**SUBJECT: COMANCHE PEAK NUCLEAR POWER PLANT – NRC DESIGN
BASES ASSURANCE INSPECTION (TEAMS) REPORT 05000445/2018010
and 05000446/2018010**

U.S. NUCLEAR REGULATORY COMMISSION
Inspection Report

Facility: Comanche Peak Nuclear Power Plant, Units 1 and 2

Component Cooling Water Make-up Procedural Deficiency

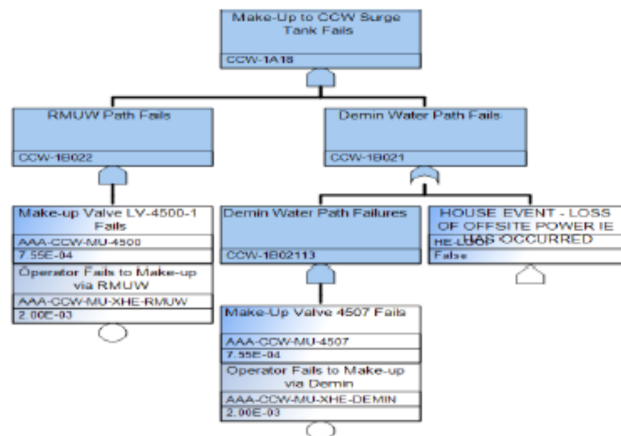
The analyst modified Fault Trees CCW-1A, "Component Cooling Water Unit 1, Loop A," and CCW-1B, "Component Cooling Water Unit 1, Loop B," to add a failure mechanism for failure of make-up to the surge tank under "OR" gates CCW-1A-1, "Component Cooling Water Loop A is Unavailable," and CCW-1B-1, "Component Cooling Water Loop B is Unavailable." The failure mechanism was made in the form of an "AND" gate representing failure of component cooling water surge tank make-up capability from its two sources. Under this "AND" gate for make-up failure, a gate modeling failure of the Reactor Make-Up Water path and a gate modeling failure of the Demineralized Water path were made.

- Failure for the Demineralized Water path was modeled with an "OR" gate with House Event for a Loss of Offsite Power OR-ed with make-up valve 4507 failing AND-ed with a human error event for operators being unable to recover from the valve 4507 failure.
- Failure for the Reactor Make-Up Water path was modeled with an "AND" gate with make-up valve LV-4500-1 failing AND-ed with a human error event for operators being unable to recover from the valve LV-4500-1 failure.

The valve failure probabilities were assigned used Template Event ZT-AOV-FTOC, "Air Operated Valve Fails to Open," which had a failure probability of 7.55×10^{-4} . For the human error events, the analyst assigned extra time to the time available performance shaping factor for diagnosis while keeping all other performance shaping factors nominal to obtain a failure probability of 2.0×10^{-3} . The new gate which is typical of both component cooling water trains is pictorially depicted below:

To model the performance deficiency, the analyst changed the procedure performance shaping factor for action to "Not Available," making the probability $5.1\text{E-}2$ that operators would fail to make-up to the component cooling water surge tank. The maximum exposure time of one year was used since the performance deficiency has existed for at least one year. This modeling of the performance deficiency yielded an estimate of $7.8\text{E-}8/\text{year}$ for the increase in core damage frequency from internal events.
